179 Presumpscot St.  
Warehouse / Storage

**CITY OF PORTLAND, MAINE  
DEVELOPMENT REVIEW APPLICATION  
PLANNING DEPARTMENT PROCESSING FORM  
Planning Copy**

**TO:** Jonathan Spence - Planner  
**FROM:** James Seymour P.E.  
Development Review Coordinator, Sebago Technics, Inc.  
**RE:** 179 Presumpscot Street–Richard P. Waltz-Proposed Warehouse/Office  
Renovation  
**DATE:** May 28, 2002

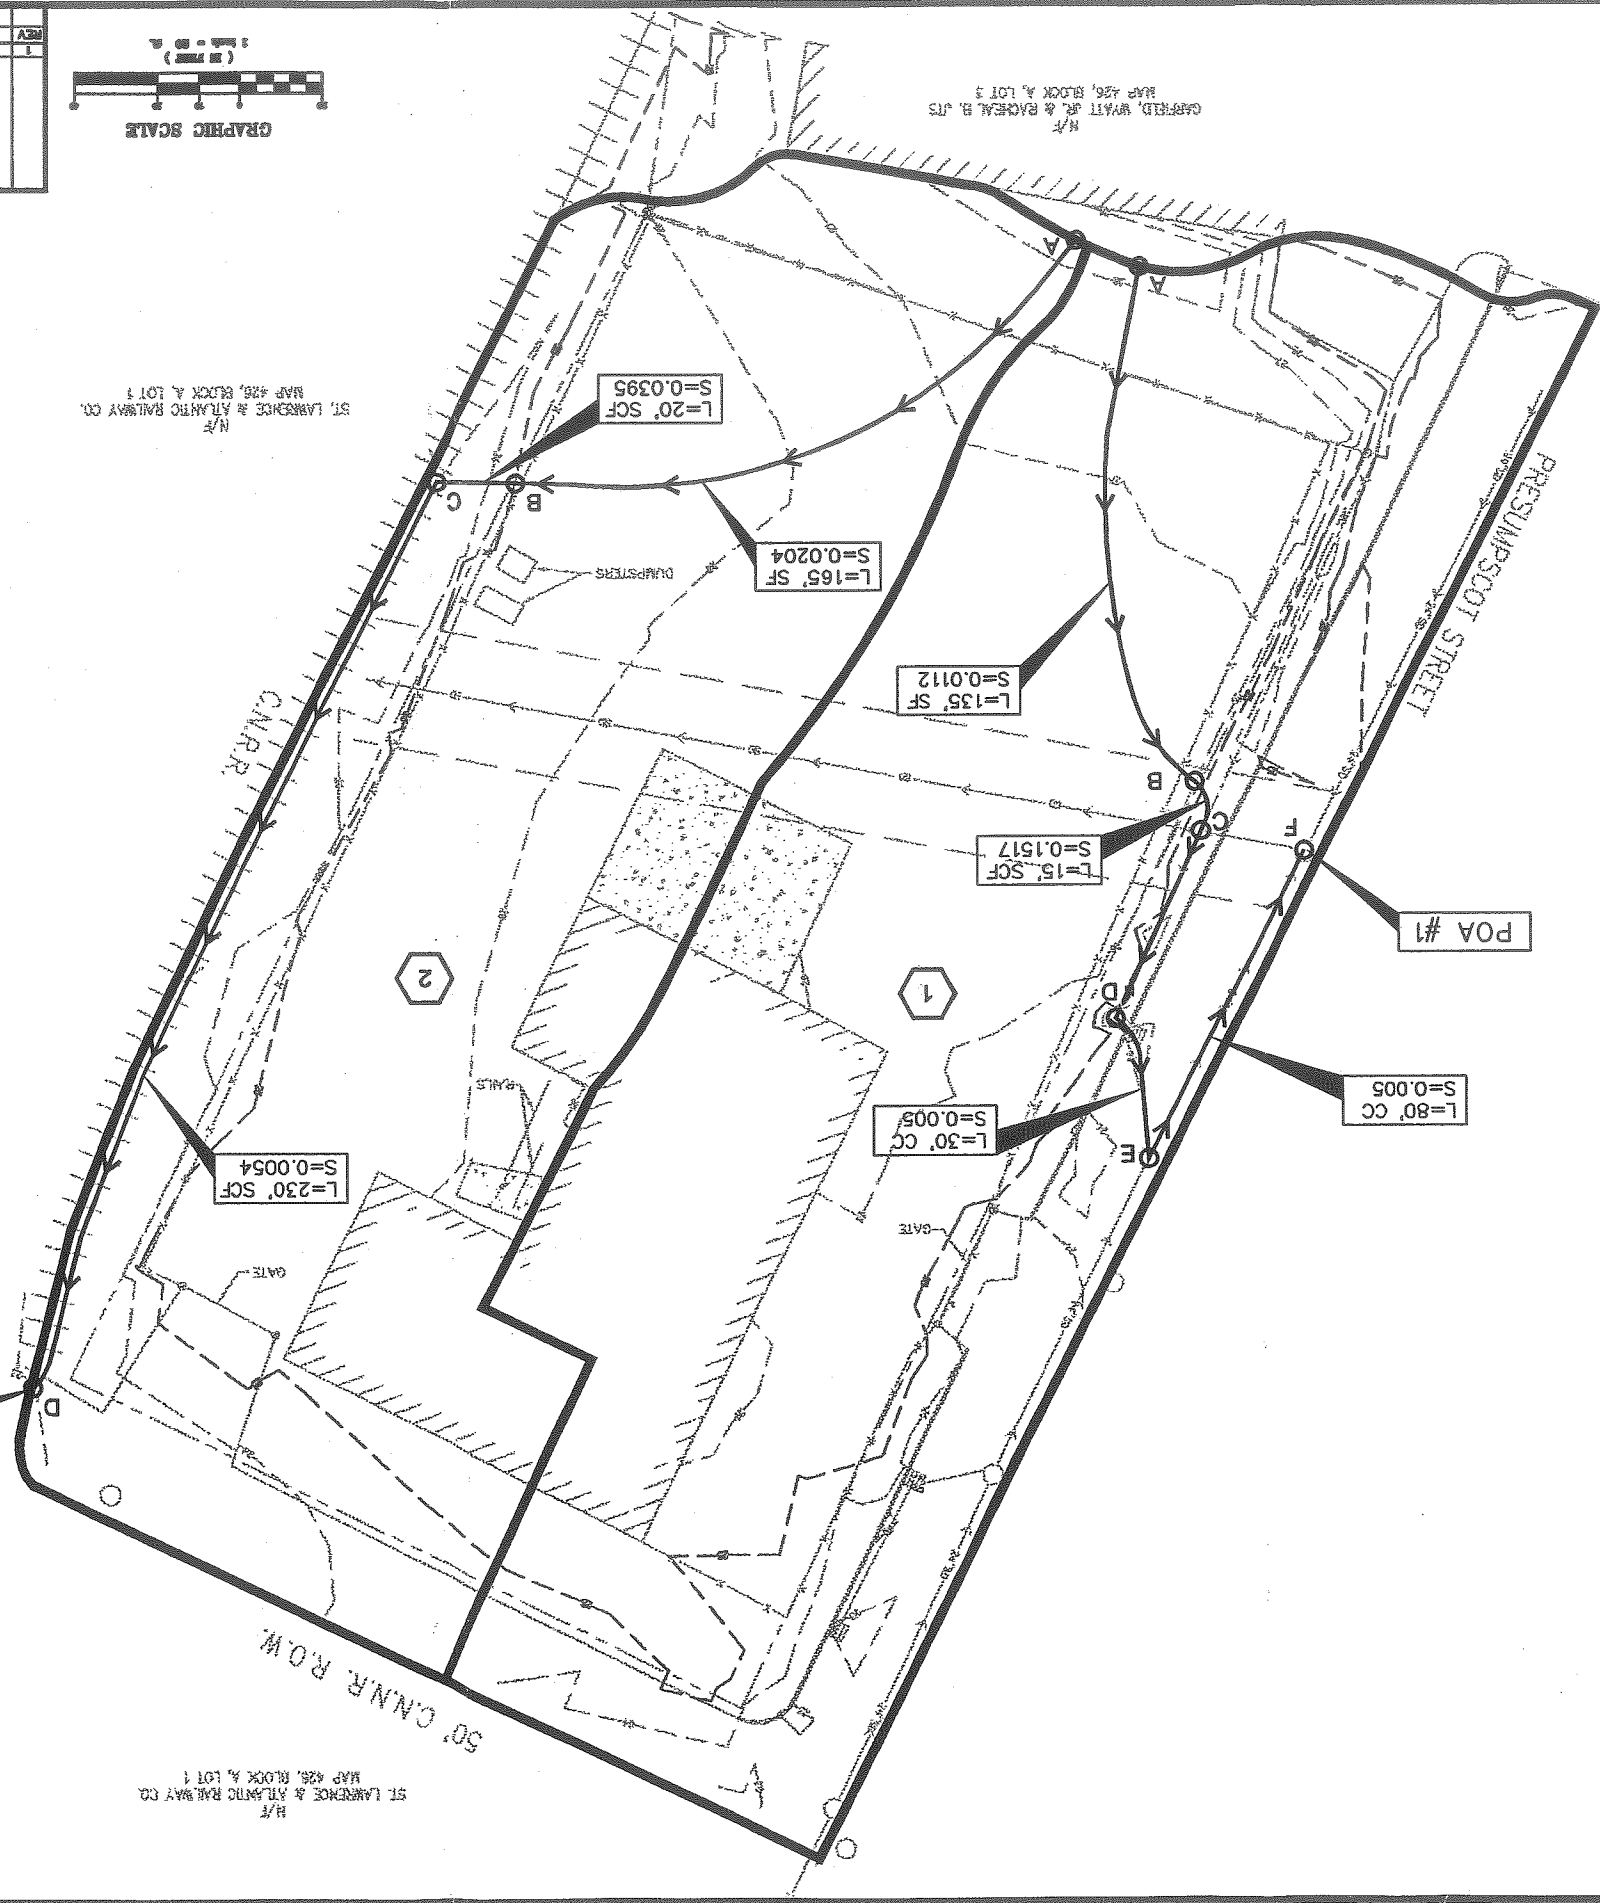
The plans (Sheet 2) do not show the existing or proposed vegetation discussed in sections 6.6, 6.7 and 6.25 of the application document.

The plan set includes a detail of proposed pavement adjacent to existing pavement, however the development description indicates that the site will be re-paved and re-graveled in the same areas as existing pavement and gravel. Please clarify on the plans the areas of existing and proposed pavement and gravel re-surfacing. My concern here is whether the assertion made in the stormwater runoff evaluation that re-development of the site does not increase the impervious surface area post development runoff is correct.

The development description indicates that erosion control during construction will not be required and will be placed at the discretion of the contractor. The plan set should be modified to reflect erosion control measures to be employed during the hauling and placement of the proposed gravel surfaces. My concern here is the tracking of sediment off site during asphalt and gravel pavement operations.
